Nat. Hazards Earth Syst. Sci. Discuss., author comment AC1  
<https://doi.org/10.5194/nhess-2021-382-AC1>, 2022  
© Author(s) 2022. This work is distributed under  
the Creative Commons Attribution 4.0 License.

## Reply on RC1

Author comment on "Assessment of building damage and risk under extreme flood scenarios in Shanghai" by Jiachang Tu et al., Nat. Hazards Earth Syst. Sci. Discuss., <https://doi.org/10.5194/nhess-2021-382-AC1>, 2022

Figure 2. Risk analysis chain

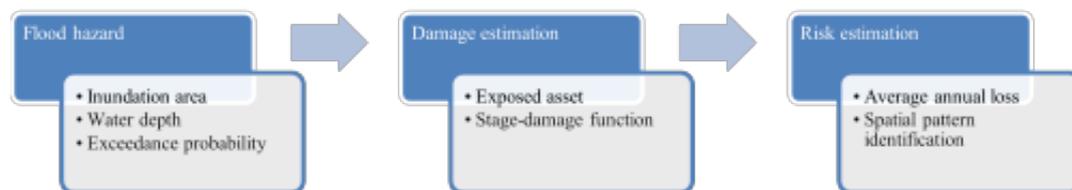
**Thank you for inviting me to review the manuscript entitled 'Assessment of building damages and adaptation options under extreme flood scenarios in Shanghai'. This manuscript assesses possible exposure and damage losses of buildings in Shanghai and provides a detailed description of the technical methods and results using the case study. It is well written, and the results are clearly presented. However, my primary concern is about its theoretical or methodological contributions to the field of flood risk assessment, which are not sufficiently articulated or developed. Assessing very extreme flood scenarios (e.g., return period = 5,000 years) is not innovative enough by itself.**

Response: First of all, thank you so much for pointing out that the theoretical or methodological aspects of the flood risk assessment are not sufficient. To introduce the methodology more clearly, we re-constructed and rewrote the paper. For example, we deleted the section "data and methods" and added the new sections "Study area" and "Materials and methods". We have also rewritten other parts of the manuscript. For the new section "Materials and methods", we included one graphic at the beginning of the section to clarify our methodological procedure:

*In our study, the flood damages in Shanghai are estimated using three different steps (Figure 2): first, extreme flood scenarios with a return period of 1/200, 1/500, 1/1000, and 1/5000-years are simulated by a hydrodynamic model. This was done in a previous work by Wang et al., (2019). Our study builds upon these results and estimates the damages based on the obtained flood hazard maps. Finally, the overall flood risk and its spatial pattern for buildings in Shanghai, described as the estimated average annual loss*

(AAL), is calculated using a polynomial regression analysis. More details of the assessment are introduced in the following sections 3.1 to 3.3.
